MFN 03-115
October 13, 2003

Subject: **Response to Request for Additional Information (RAI) numbers (117.2, 306, 314.1, 322, 323.4, 329, and 406) for ESBWR Pre-application Review - Supplementary Information**

Response to NRC RAI numbers (117.2, 306, 314.1, 322, 323.4,
329, and 406) – Supplementary Information

PCC Vent Line

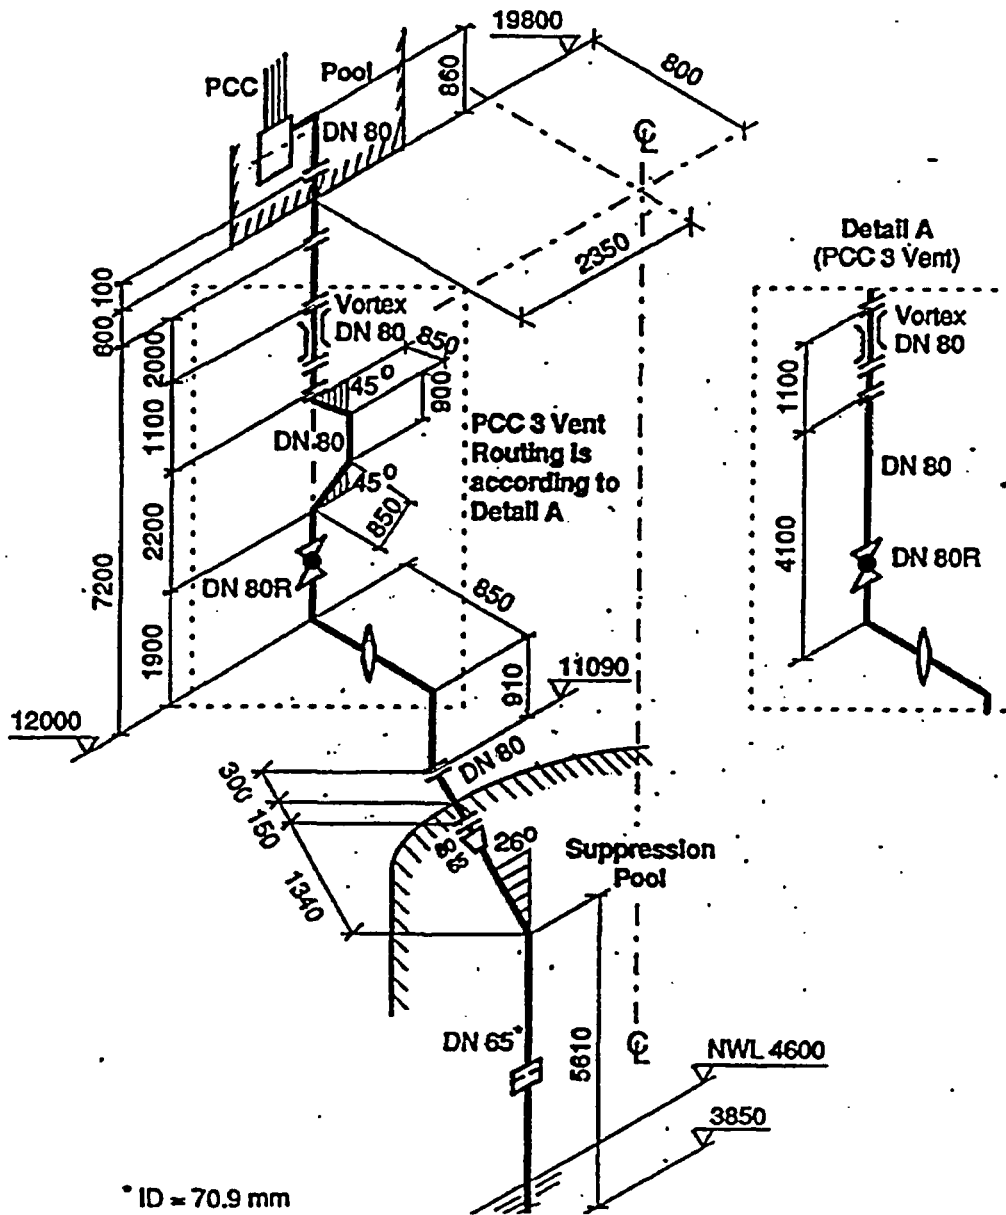
Supplementary Information for RAI 117.2

PCC Vent Pressure Tap – Located on downstream side of vortex flow meter

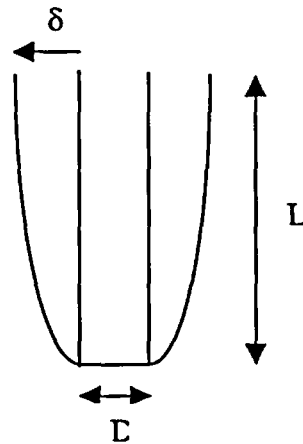
PCCS Performance During Blowdown

In response to RAI 314.1, it was stated that the PCCS removes about 15% of the blowdown energy. In response to RAIs 335 and 340, it was stated that the PCCS vent submergence is deep enough to avoid stratification but not so deep that it stops the vent function.

1. Provide a road map locating the source of data that demonstrates the PCCS performance (to condensing steam) during the blowdown portion of the event. Under these conditions (flow rates, steam and noncondensable fractions) will the PCCS condense 100% of the steam?
2. If the PCCS cannot condense 100% of the steam, provide a road map locating the source of the data that demonstrates that the PCCS vent submergence is low enough to condense the steam in the suppression pool, such that only noncondensable gases enter the wetwell.

1 The attached Figure 1 shows the flow rates through the PCCS calculated by TRACG for the first 2000 seconds of the transient. The flow is for 3 PCC units lumped into one in the TRACG model. Hence the flow per PCC is the flow shown in the figure divided by 3. Most of the flow in this phase flows through the main vents. The PCC flow varies from approximately [[]]. Figure 2 shows the noncondensable partial pressure at the PCC inlet during the same time period. After clearing out the noncondensibles above the steam line break location in the first couple of seconds, the flow is essentially all steam until 10 minutes into the transient. The flow rate of [[]] is within the test database of the PANTHERS tests. At PANTHERS, a full SBWR-scale PCC unit was tested over a steam flow range between [[]]. Steam-air tests were also conducted over the same steam flow range combined with an air flow range of [[]] (Table A.3-2 of ESBWR TAPD, NEDC-33079P). The ESBWR PCC has similar dimensions but has [[]] tubes. The steam only tests were conducted allowing the PCC pressure to adjust such that all the incoming steam was condensed. Figure 4.1-14 in NEDC-32725P, TRACG Qualification for SBWR, Vol. 1, shows that TRACG calculated the required pressure to condense the steam flow conservatively. (The data point on the right side of the figure corresponds to a steam flow rate of [[]]). Figure 1 also shows that a part of the steam flowing through the PCCs is not condensed. The uncondensed steam flow drops from [[]] to a small value at 300s. Beyond this time, a combination of increase

in PCC pressure and reducing steam flow through the PCCs allows the PCC condensing capacity to catch up with steam flow.

The most relevant data for condensation efficiency of steam discharged through the PCC vent can be found in Reference 1. In the LINX test facility, tests were performed with a vent pipe with an I.D. of 40 mm and submergences ranging from 37.5 to 75 cm. Steam flow rates ranged up to 50 g/s. This mass flux corresponds to a flow rate of [[]] in an ESBWR-size vent of [[]]. The test data showed that the steam was fully condensed in all the tests, with even low submergences until the pool temperature got to a few degrees below saturation. At typical subcoolings, the steam was condensed at a distance of 10 to 15 cm ($L/D = 3$ to 4) above the vent discharge. A simple argument can be made that condensation will be complete for a pipe of a different size at the same L/D or less when the mass flux is the same. Assuming equal L/D , the required submergence is of the order of [[]].
